TO: ALL PLANHOLDERS
FROM: CARL L. COOK, P.E., PROJECT ENGINEER *CLC*
PROJECT: MAPLETON CITY SECONDARY WATER SYSTEM, PHASE 1
DATE: APRIL 21, 2011
SUBJECT: ADDENDUM NO. 2

**MAPLETON CITY SECONDARY WATER SYSTEM, PHASE 1
ADDENDUM NO. 2**

201005-001
PROJECT NO.
SEE PROJECT FILE
FILE GRAND PLOT
SHEET PH-2
58 of 111 SHEETS

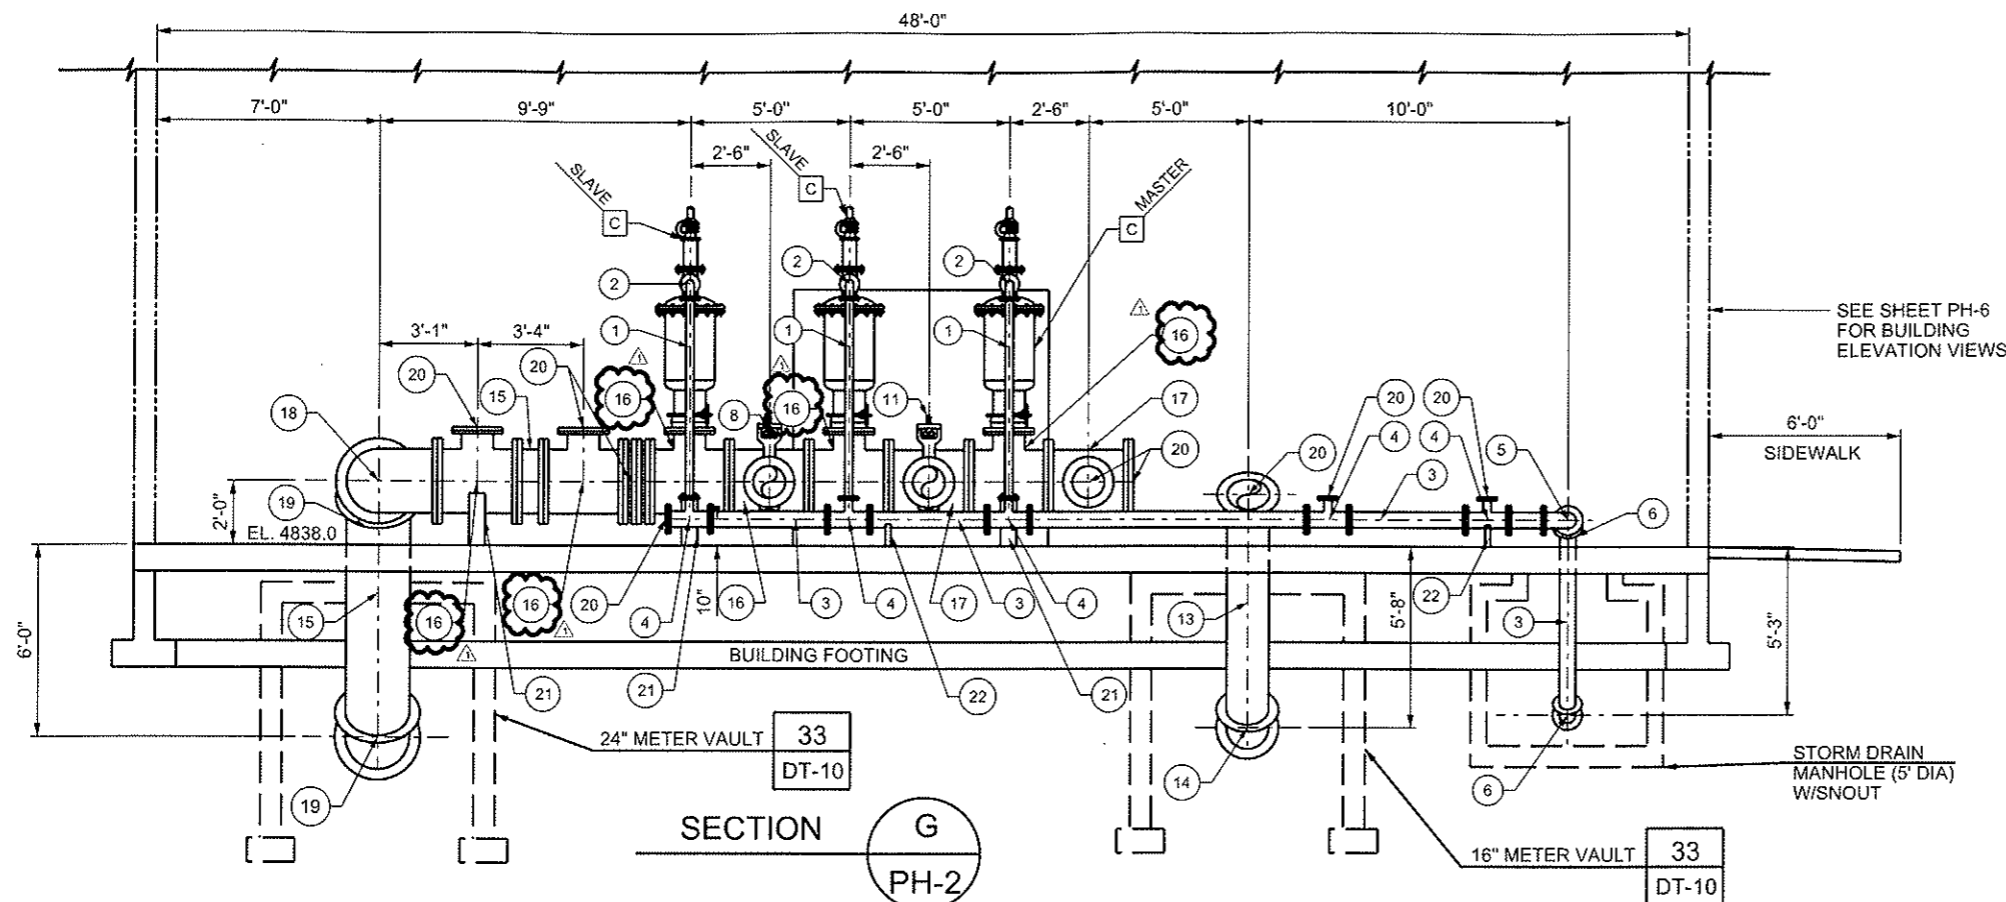
- E. The Contractor's GENERAL WARRANTY AND GUARANTEE for this project is agreed to be ONE (1) YEAR from the date of final acceptance of the project, unless otherwise specified and mutually agreed upon elsewhere in this contract.
4. PLAN SHEETS PH-2 AND PH-3: Replace Sheets PH-2 and PH-3 of the Contract Drawings with the Revised Sheets PH-2 and PH-3 attached to this ADDENDUM No. 2. The Revisions modify the size of some manifold fittings and clarify piping in the Pump Station which connect to the Self-Cleaning Filters.
5. SECTION 22 11 23 WATER PUMP: Amend this Section as follows:
 - Paragraph 2.8.C: Flowserve brand pumps are considered as an approved equal subject to the design requirements specified.
 - Paragraph 2.8.H.1: Motor shall be rated for a minimum elevation of 4900 feet msl.
